Title of Change:	Typo corrections in the datasheet for better datasheet integrity
Effective date:	19 Feb 2020
Contact information:	Contact your local ON Semiconductor Sales Office or Ladislav.Bazant@onsemi.com
Type of notification:	This Product Bulletin is for notification purposes only. ON Semiconductor will proceed with implementation of this change upon publication of this Product Bulletin.
Change Category:	Datasheet change
Change Sub-Category(s):	Datasheet/Product Doc change

Description and Purpose:

NCV7685DQR2G

Figure 1. Block Diagram

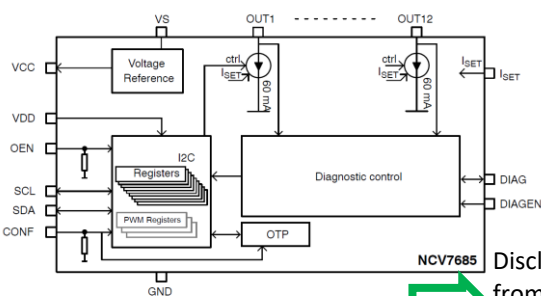
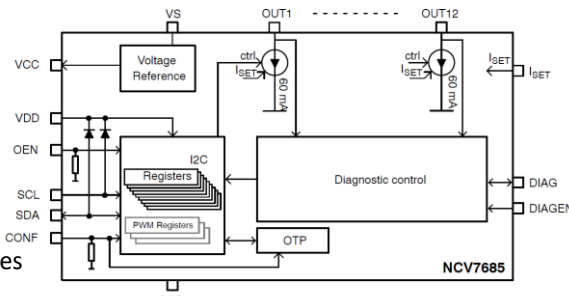
- SCL arrow change
- Internal ESD diodes added

Disclose the internal ESD diodes from SCL SDA to VDD

Figure 4. Application Diagram without Micro-controller (Stand Alone Mode)

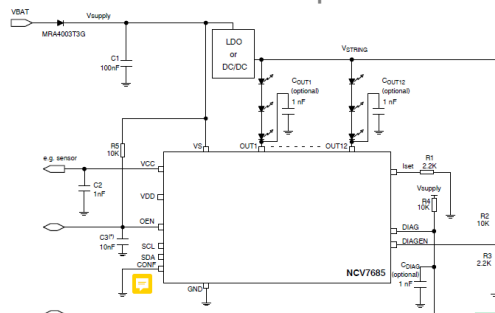
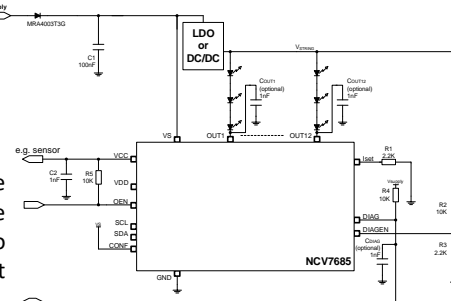
- CONF and OEN pin connection

If the CONF pin is put to High, the LEDs are automatically activated in the standalone mode.

RC filter for OEN pin may not be sufficient. It is better to activate the OEN pin via VCC output reference to have 0 V during the VS startup for first 10µs.

Figure 6. Power-up sequence

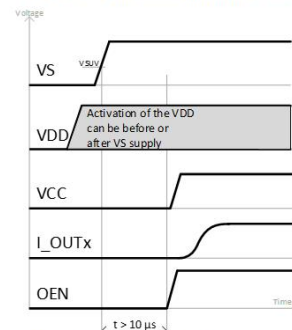
Adding Power-on Sequence figure
